## 6.6 Permit Processing/Public Comment

Pursuant to IC 13-15-5-1, the draft NPDES permit for the ArcelorMittal Indiana Harbor, LLC – Indiana Harbor West was made available for public comment from August 15, 2011, through September 30, 2011, as part of Public Notice No. 2011-8F-RD/PH. In addition, a public hearing was held in Gary, Indiana, on September 15, 2011. During the comment period and at the public hearing, comments were received concerning the draft permit. Comments received at the hearing and/or submitted via email, and this Office's corresponding responses, are summarized below. Any changes to the permit and/or fact sheet are so noted below.

#### Dissolved Metals Translators

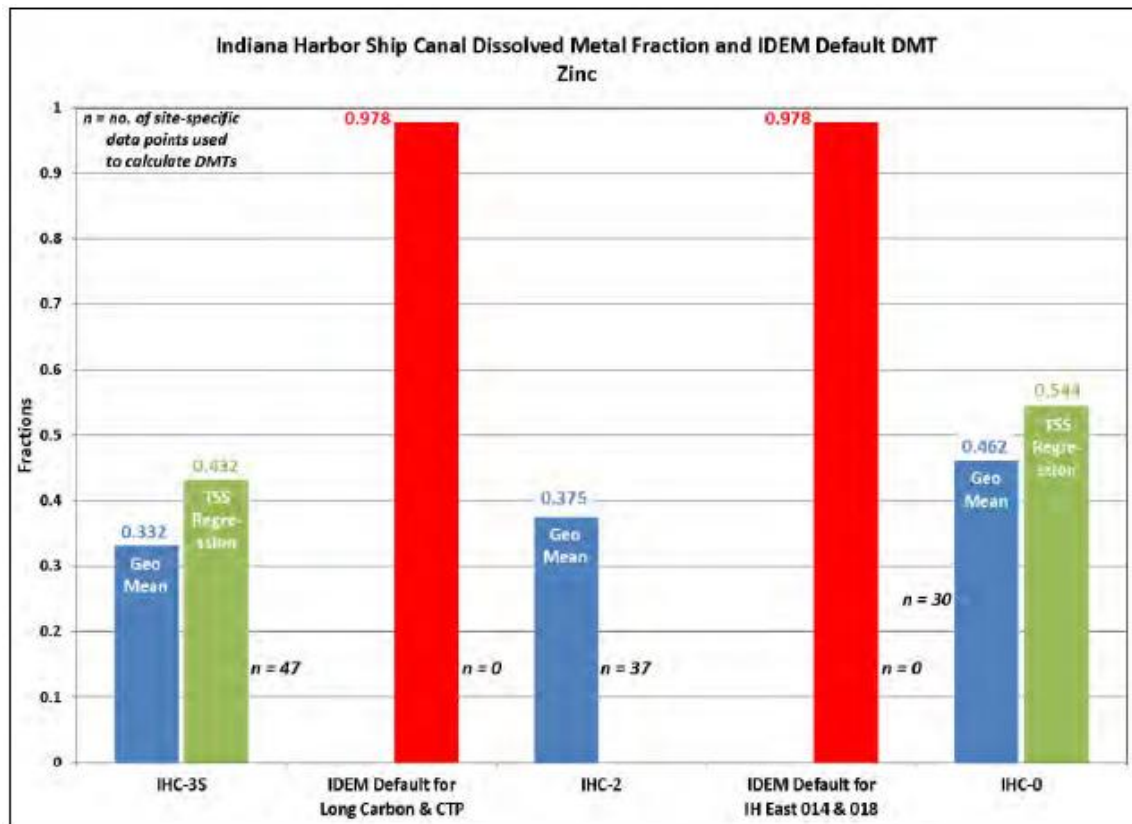
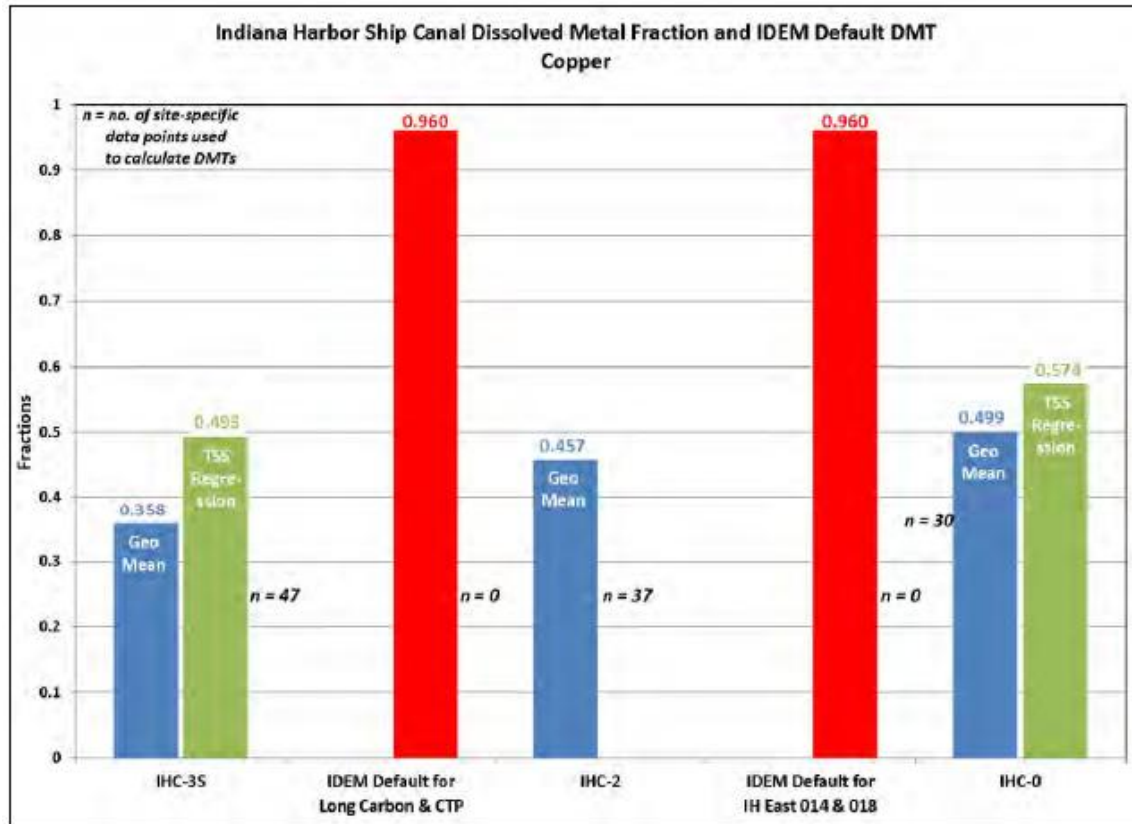
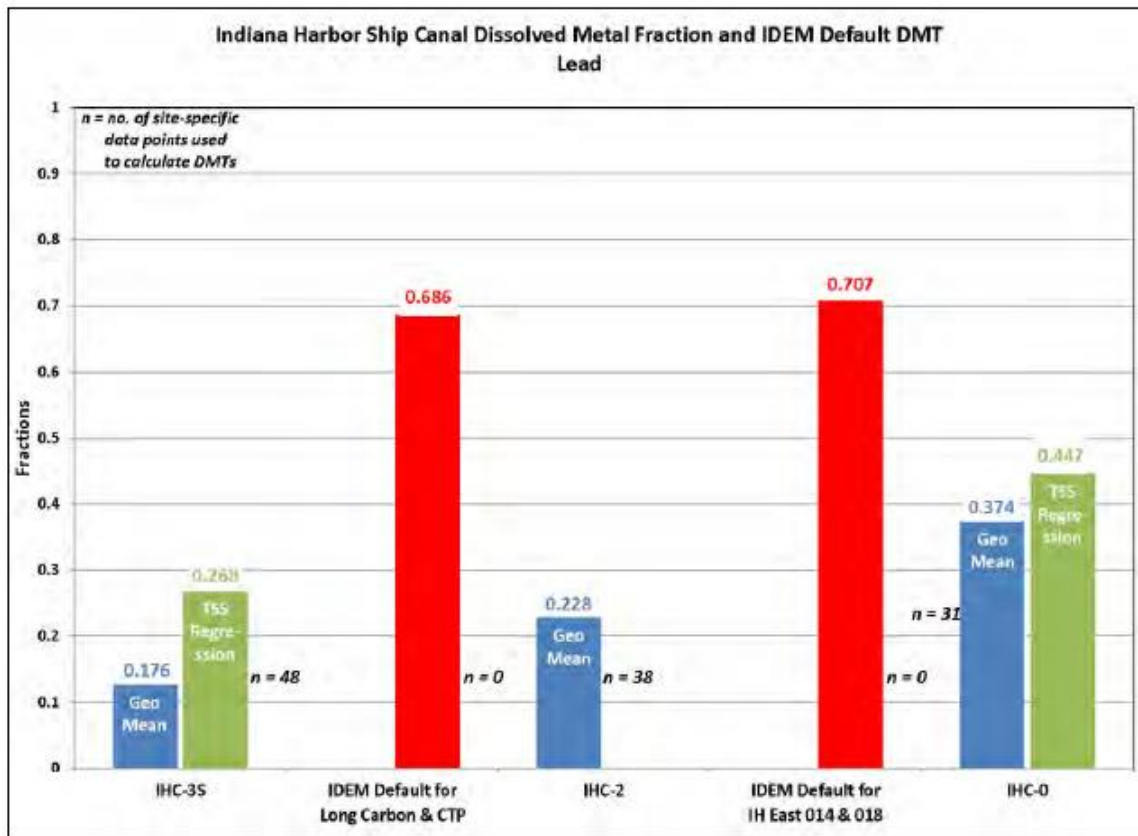
Total and dissolved data for copper, lead and zinc collected by IDEM from the Indiana Harbor Ship Canal at fixed monitoring stations IHC-2 (Dickey Road) and IHC-0 should be used to calculate site-specific dissolved metals translators (DMTs). These DMTs should be used in the calculation of preliminary water-quality based effluent limits for the Central Treatment Plant (CTP) Outfall 001, and Indiana Harbor East Outfall 014. Data collected by IDEM over a period of several years for these metals demonstrate that the majority of the copper, lead and zinc present is associated with particulate in the water column and is not in the dissolved form. Dissolved metals more closely approximate the bioavailable fraction in the water column than do total or total recoverable metals. Consequently, use of site-specific DMTs is well suited for the IHSC. The Dickey Road fixed monitoring station, located downstream of CTP Outfall 001, serves as an appropriate data set for calculating DMTs for development of QBELs for CTP Outfall 001. IDEM should consider the Dickey Road data representative of conditions in the IHSC and reliable because IDEM used the lead and zinc data collected at Dickey Road for another purpose in the NPDES permit renewal process for the ArcelorMittal facilities (*i.e.*, Dickey Road data were used to project the effluent quality from Indiana Harbor West Outfall 007 in IDEM’s multi-discharger WLA). The IHC-0 fixed monitoring station is located downstream of Indiana Harbor East Outfall 014.

Per EPA guidance<sup>2</sup>, DMTs can be calculated as the dissolved to total metal fraction, and can be calculated from a correlation of the dissolved fraction to receiving stream TSS concentration. Following that guidance, DMTs for copper, lead and zinc were calculated from the Dickey Road and IHC-0 data and are summarized below. The dissolved and total metals data used in the DMT calculations are attached (see Attachment IHC-1). For comparison, IDEM's default translators that were used in the development of the proposed permit limits, and DMT's calculated from data collected by IDEM at fixed Station IHC-3S are also shown.

As noted in a prior response, IDEM does not believe it is acceptable to re-establish background at Dickey Road and has not received a site-specific metals translator study so the current multi-discharger model was not revised. IDEM did look at the impact of lowering the ArcelorMittal Long Carbon allocation, as requested, and did not find a significant impact on the calculation of downstream WQBELs. For future wasteload allocation considerations, a site-specific metals translator along with more refined effluent concentration characteristics will provide the greatest means of showing that more assimilative capacity is available than currently modeled.
